Access Compliance Report

Public Rights-of-Way

Main Street: VAN_BUREN_ST Cross Street: WASHINGTON_AVE Location: NE

ADA ID: RPRK210930165755 Ramp Type: Type 1 - Perpendicular Diagonal Initial Pass/Fail: Fail Overall Compliance: No Severity Score: 20

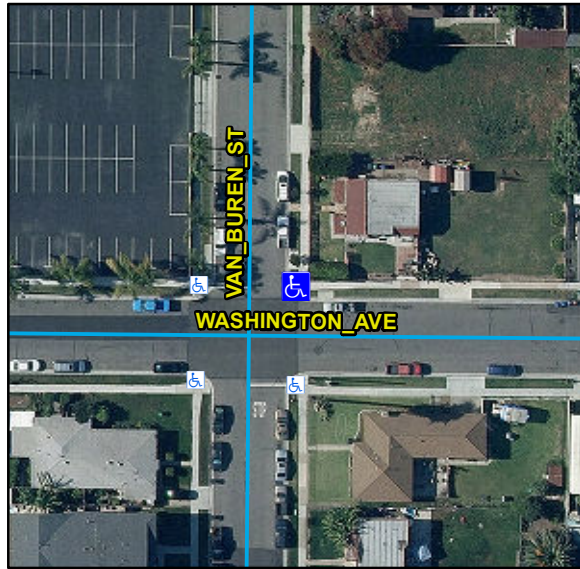
Compliance	Description	Data	Compliance	Description	Data
N/A	Ramp Length (in)	105	N/A	Flare Type LT	
No	Ramp Width (in)	36			N/A
No	Ramp Run Slope (%)	9.9	N/A	Flare Slope LT (%)	N/A
No	Ramp Cross Slope (%)	2.3	N/A	Flare Traversable LT	N/A
N/A	Landing Present	N/A	N/A	Flare Type RT	
N/A	Landing Length (in)	N/A			N/A
N/A	Landing Width (in)	N/A	N/A	Flare Slope RT (%)	N/A
N/A	Landing Run Slope (%)	N/A	N/A	Flare Traversable RT	N/A
N/A	Landing Cross Slope (%)	N/A	N/A	DWS Provided	N/A
N/A	Landing Movement Obstructed?	N/A	N/A	DWS Contrast	N/A
	Landing Movement Type	N/A	N/A	DWS Length (in)	N/A
N/A	Landing Shared	N/A	N/A	DWS Full Width	N/A
N/A	Clear Space	Yes	N/A	DWS Offset Left (in)	N/A
N/A	Clear Space To Crosswalk (in)	N/A	N/A	DWS Offset Right (in)	N/A
N/A	Marked Crosswalk 1	No	N/A	Marked Crosswalk 2	No
	Crossing 1 Direction	W		Crossing 2 Direction	S
	Marked Crosswalk 1 Width (in)	N/A		Marked Crosswalk 2 Width (in)	N/A

N/A	Ramp Inside Crosswalk 1	N/A	Yes	Ramp Inside Crosswalk 2	N/A
	Crossing 1 Slope (%)	5.5		Crossing 2 Slope (%)	0.8
	Crossing 1 Cross Slope (%)	1.8		Crossing 2 Cross Slope (%)	3.6
N/A	Gutter Ponding	N/A	No	Curb Slope	7.6
Yes	Gutter Lip Height (in)	0		Road Run Slope (%)	0.7
N/A	Gutter Run Slope (%)	N/A		Road Cross Slope (%)	5.7
N/A	Gutter Cross Slope (%)	N/A			
Yes	Overall Surface Condition: Acceptable		No	Perp Joint Present	No
	Cross Gutter Present?	No		Spandrel Present?	No
	Replace Cross Gutter?	N/A		Replace Spandrel?	N/A

Remove & Replace Curb Ramp With Two New Directional Ramps or Equivalent.
